**PLANNED UNIT DEVELOPMENT
STAFF REPORT****Date: January 6, 2011****DEVELOPMENT NAME**

Apostolic Overcoming Holy Church of God

CONTEMPLATED USEPlanned Unit Development Approval to amend a
previously approved Planned Unit Development to allow
multiple buildings on a single building site.**TIME SCHEDULE
FOR DEVELOPMENT**

SITE PLAN

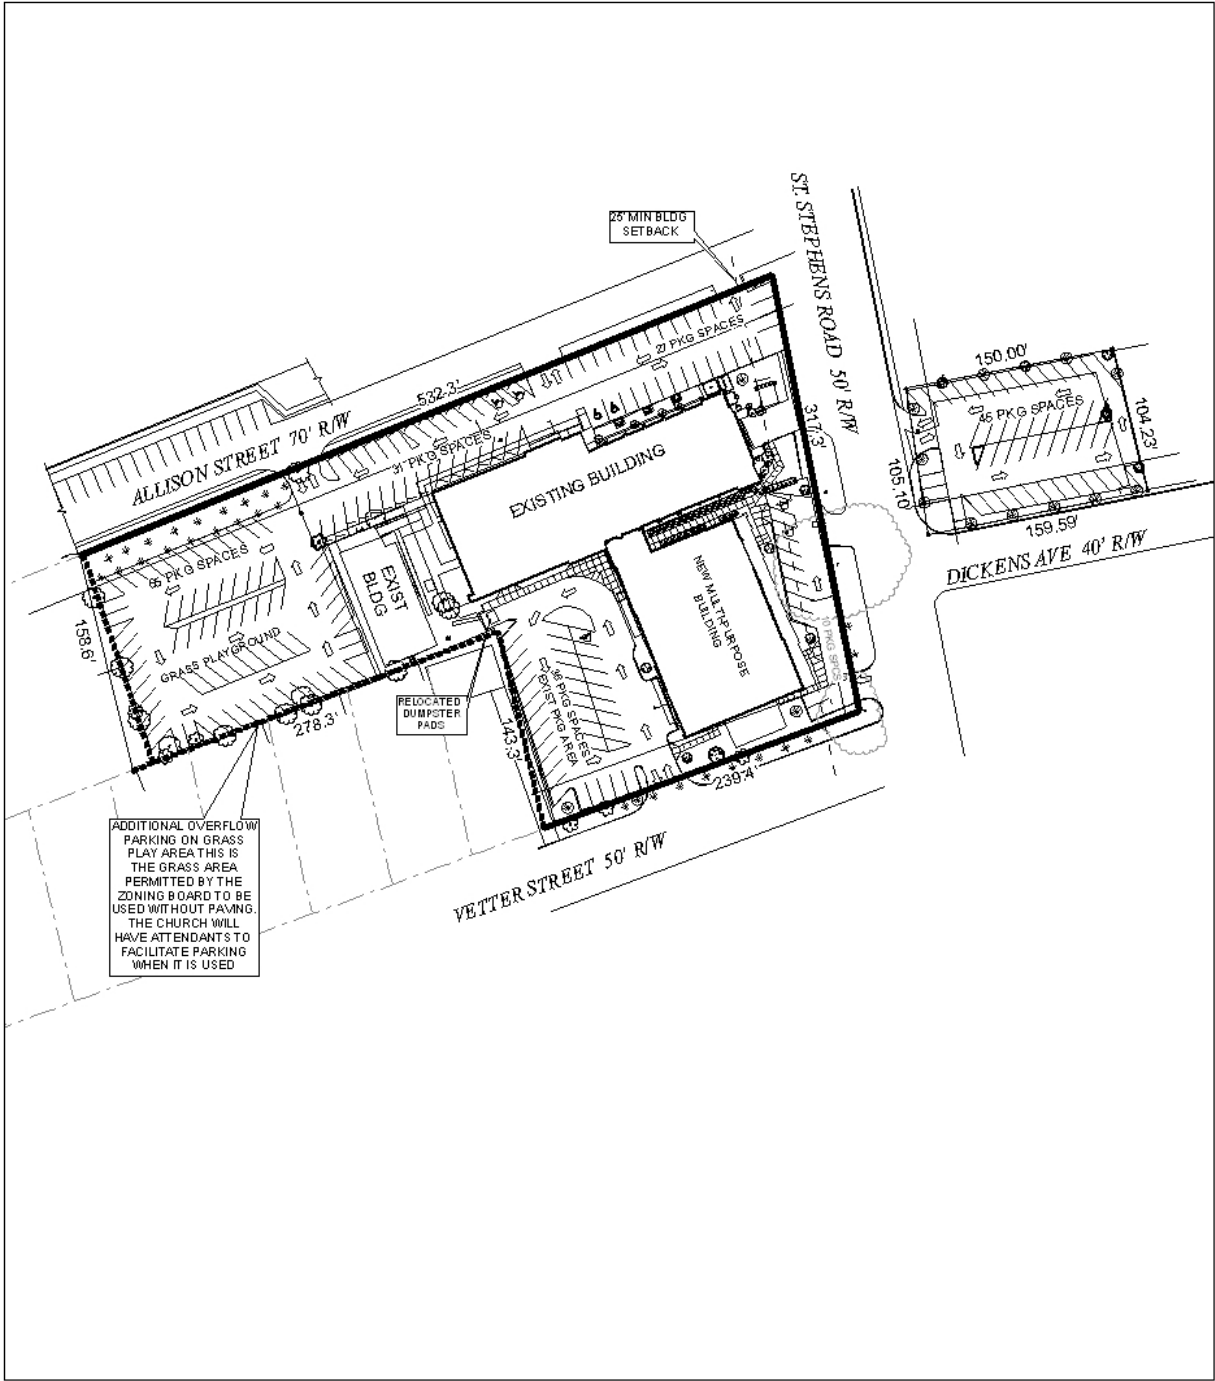
Need to show sidewalks on site plan along all property lines abutting public streets or apply for a sidewalk waiver. Must comply with all storm water and flood control ordinances. Any increase in impervious area in excess of 4,000 square feet will require detention. Any work performed in the right of way will require a right of way permit. Drainage from any new dumpster pads cannot discharge to storm sewer; must have connection to sanitary sewer.

Driveway number, size, location, and design to be approved by Traffic Engineering and ALDOT and conform to AASHTO standards. To avoid conflicts, eliminate the additional parking space at the northeast driveway on Alison Street and the two spaces at the southern entrance driveway on St. Stephens Road. Eliminate the mix of angle parking and 90 degree parking. The 90 degree parking spaces back into the parked cars in some areas. Sign and mark all one way aisles.

Although the latest variance was approved despite staff recommendations for denial due to site over-development and the inability to meet both Traffic Engineering concerns and parking ratio requirements, the site plan submitted for this PUD still has flaws. For instance, the off-site parking area was noted by Urban Forestry in the variance report to have insufficient space to meet the perimeter tree planting requirements along its North and East sides in that insufficient space is provided for the tree root balls. The variance approval condition was “*full compliance with all other municipal codes and ordinances*”. This would pertain to the proper planting of trees and the site plan submitted for this PUD still maintains the same small area allocated for the tree plantings which was found to be insufficient in the variance site plan. And the site plan inaccurately depicts the corner radius dedication required in the one-lot subdivision approval for the off-site parking area. An accurate depiction of the dedication would require revised landscaping calculations for the site, particularly along the street frontages, as none were provided for street frontages for either the off-site parking area or the main church site; only total site calculations were provided. Therefore, the site plan should be revised to accurately depict the required corner radius dedication of the subdivision and provide landscaping calculations for both the total site areas and the street frontage areas of both properties. If compliant landscaping ratios cannot be achieved and sufficient tree planting areas cannot be provided to satisfy Urban Forestry, the applicant will need to submit a variance request to cover such.

Another point of concern is the location of the fenced mechanical yard within the required 20' side street yard setback along Vetter Street. The site plan erroneously labels this as a 25' setback, but the approval of Phillips Temple A.O.H. Subdivision in 2001 required a 25' setback only along St. Stephens Road and Allison Street; therefore, a 20' setback is required along Vetter Street. The site plan should be revised to reflect this. As no structure (including HVAC equipment and generators) or fence above 3' high can be built within the required setback, the mechanical yard should be relocated to a compliant location, or a setback variance sought, or a note should be placed on the site plan indicating that nothing higher than 3' above grade will be constructed within this area.

The site plan indicates a public sidewalk only along Allison Street. All new development requires public sidewalks to be installed along all street frontages; therefore, the site plan should be revised to illustrate proposed public sidewalks where lacking or a sidewalk waiver should be submitted.

- 1) revision of the site plan to accurately depict the required corner radius dedication of the one-lot subdivision;
- 2) revision of the site plan to provided landscaping ratios for both the total site areas and the street frontage areas of both properties, or the submission of variance requests if compliant ratios cannot be achieved and sufficient tree planting areas cannot be provided to satisfy Urban Forestry;

- 3) revision of the site plan to label the Vetter Street setback as 20' instead of 25';
- 4) revision of the site plan to relocate the fenced mechanical area to a compliant location, or the submission of a setback variance, or the placement of a note on the site plan stating that nothing higher than 3' above grade will be constructed within this area; and

- 5) revision of the site plan to provide public sidewalks along all street frontages where lacking, or the submission of a sidewalk waiver application.
